From: James Neave

**Cc:** James Court; Kirstie May **Subject:** Fees Monitoirng follow-up

# ANGUS ENERGY LTD

Response to Letter CW/Lidsey Oil/FM/V7/14

## 3.2 Existing plan with updates.

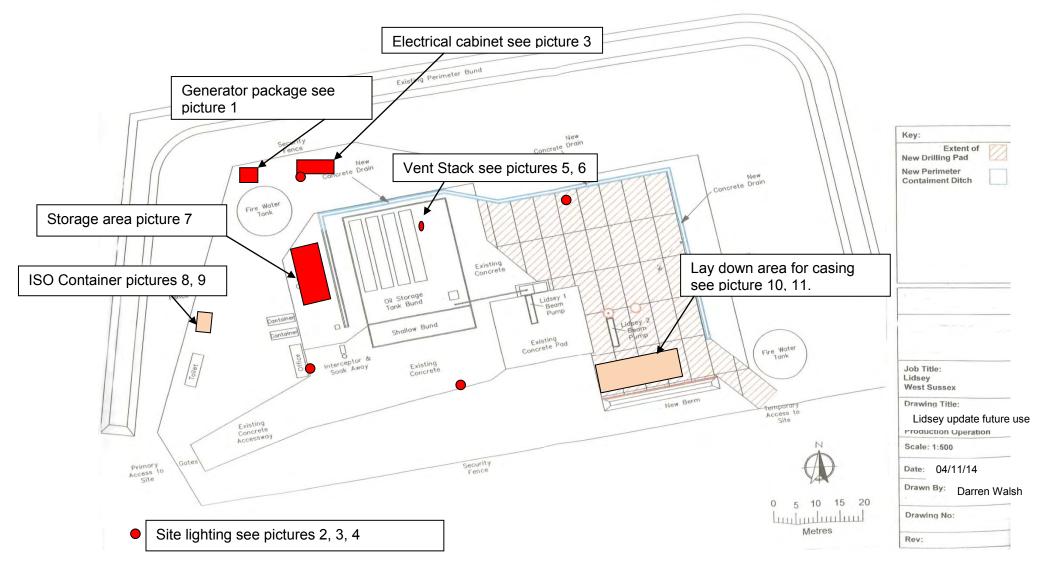
The submitted details (plan: Lidsey Update Future Use (dated 04/11/14) and attached photographic schedule) are considered acceptable. This plan and schedule now replaces PSSL/KEY/L2/PL/002 as the approved site layout for the site during production and should be read in conjunction with condition 3.

With regard to condition 11 the revised plan and pictures 5 & 6 provide sufficient detail.

7. Existing storage area

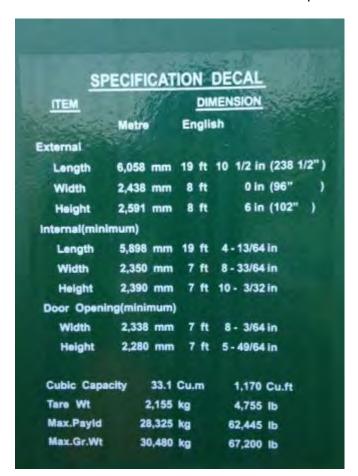
Notwithstanding the above, with regard to the storage area adjacent to the site office (picture 7) this area must only be used for the **storage of equipment directly associated with operations on this site and no equipment stored here shall exceed 6m in height**. In this regard picture 7 is only considered as indicative. A note of this will be made on the photographic schedule and equipment/plant stored therein shall be reviewed at the next site visit made by officers.

-INDICATIVE

6M MAX HEIGHT,

ONLY STE FOR

PLANT/EQUIPMENT TO

BE USED ON SITE.
